Public Works
Duplin County
N.C. Cooperative Extension – Duplin County Center
165 Agriculture Dr.
Kenansville, NC, 28349

Addendum Number 2

Hurricane Florence EWP (Environmental Watershed Protection) – Construction Phase Bid

August 17th, 2022

DARK BRANCH P&P - 0+00.00 TO 5+78.00

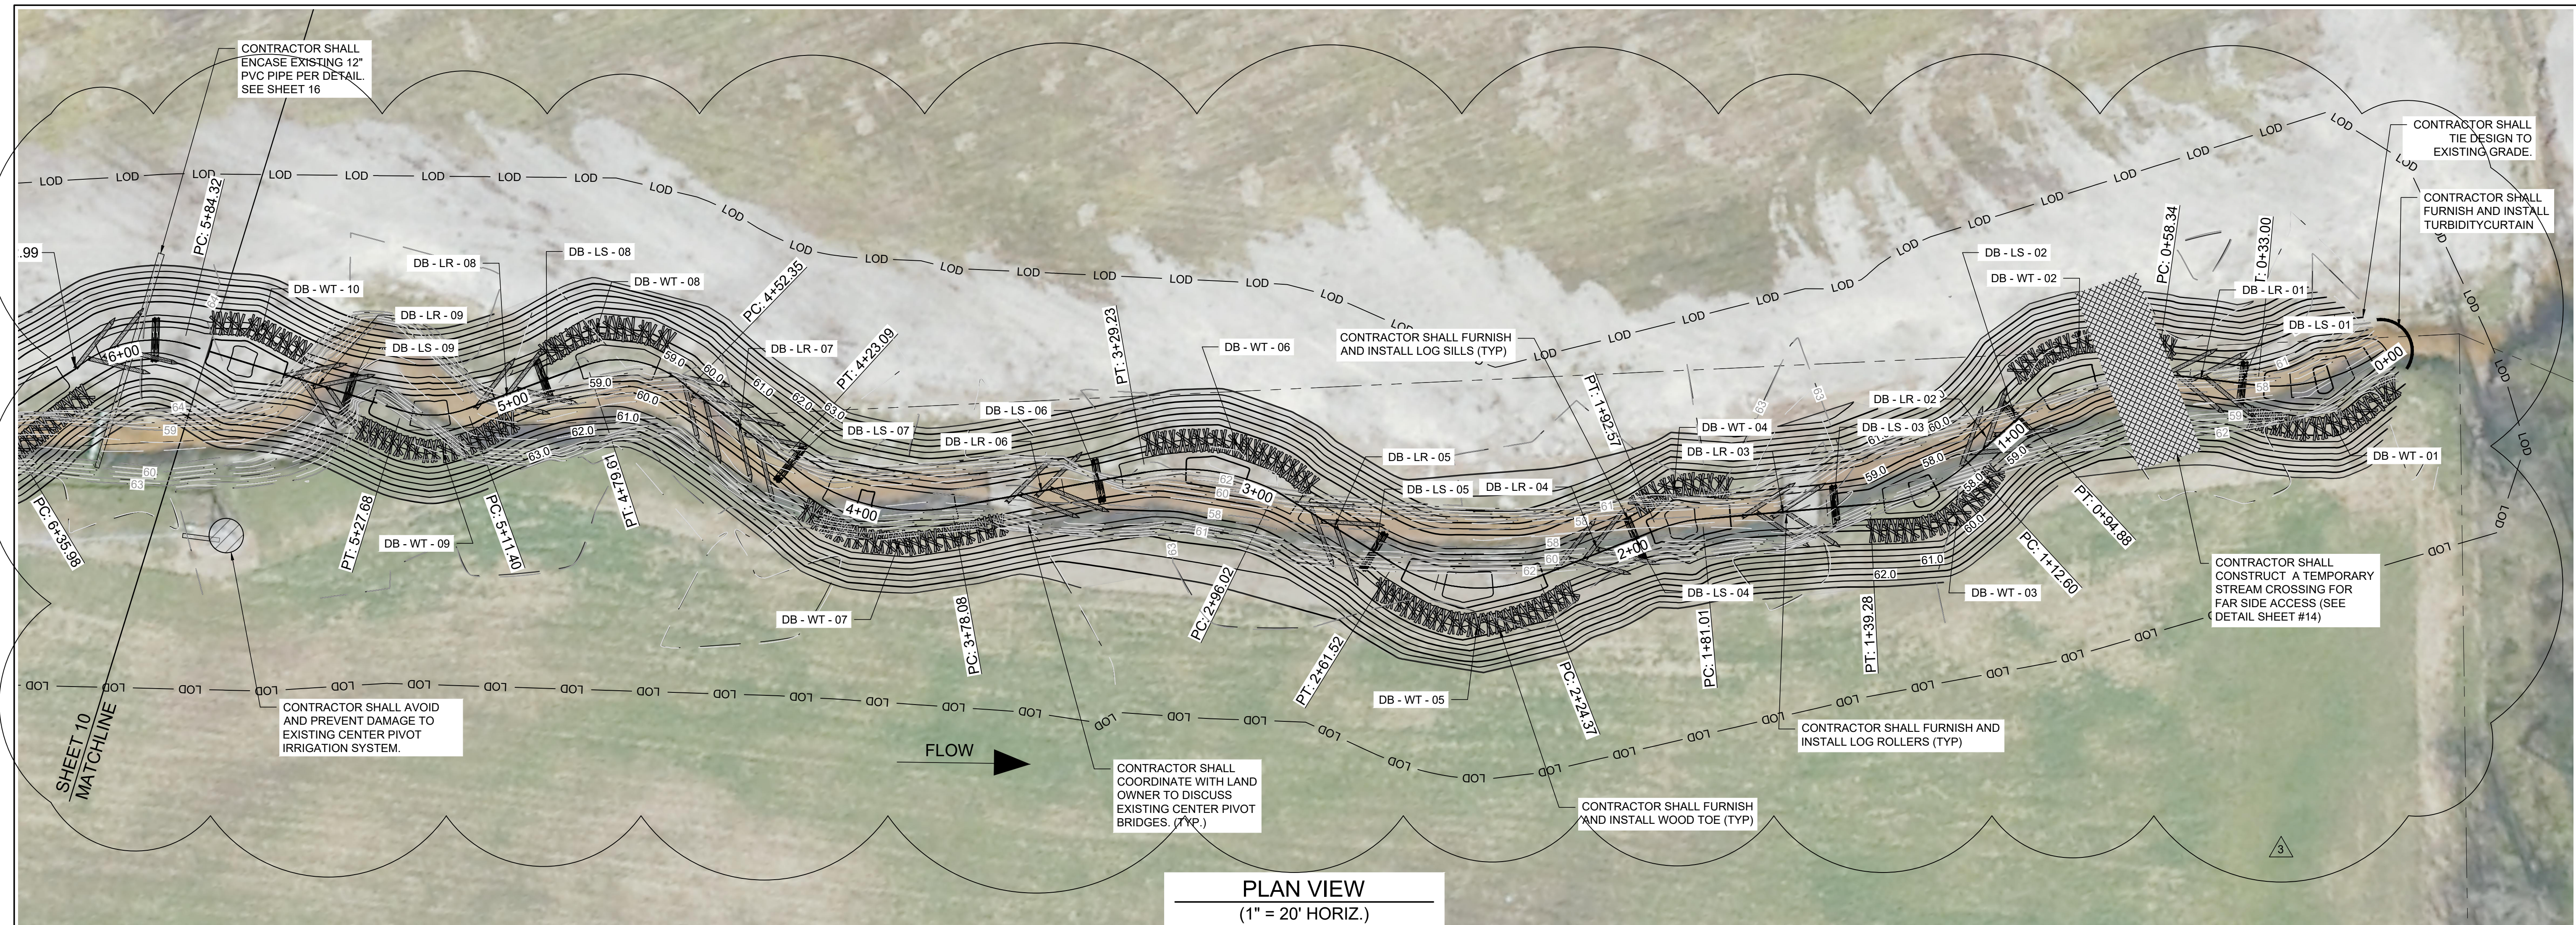
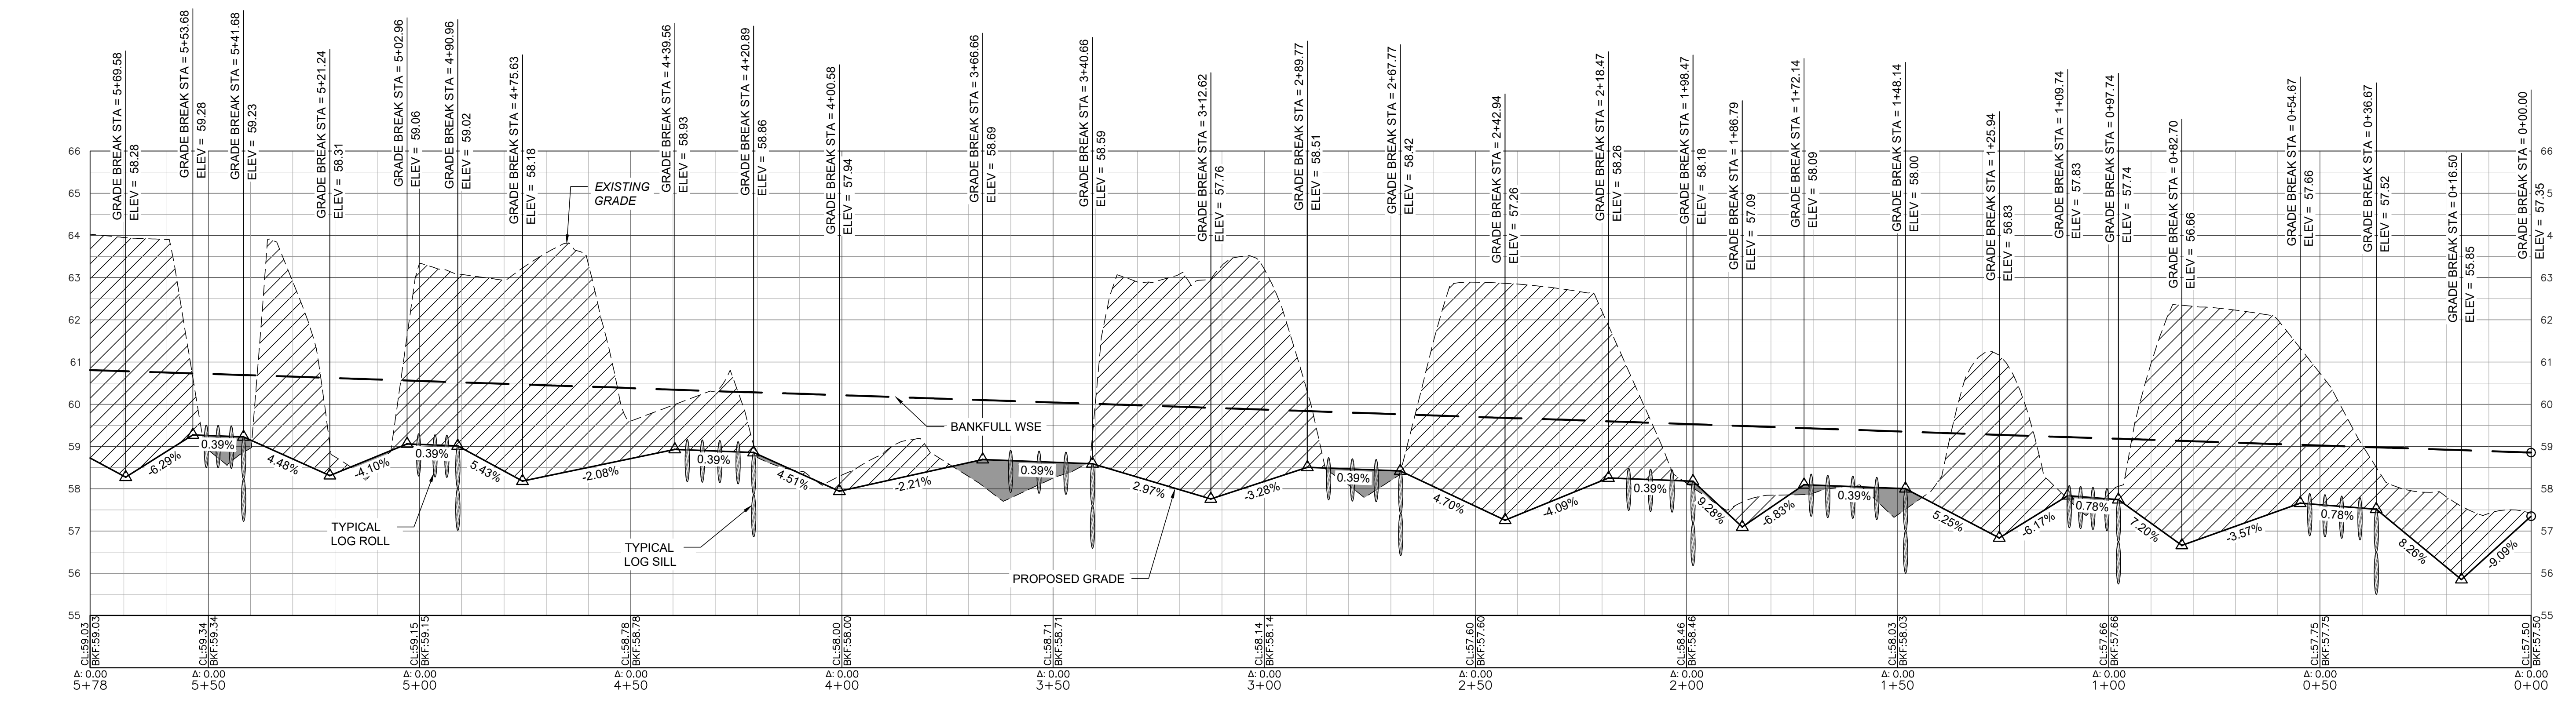
1. Revisions have been made to sheets #9 and #10, addressing the overall width of the channel, contractor is advised to review these sheets as the cut/fill volumes have dropped from approximately 4500 cy. Cut to 1,800 cy. Cut. Contractor remains responsible for verifying all quantities including but not limited to grading volumes.
2. Federal procurement requirements: We want to explain the DBE participation and federal procurement requirements for this contract. Per the attachment within the solicitation documents the contractor shall:
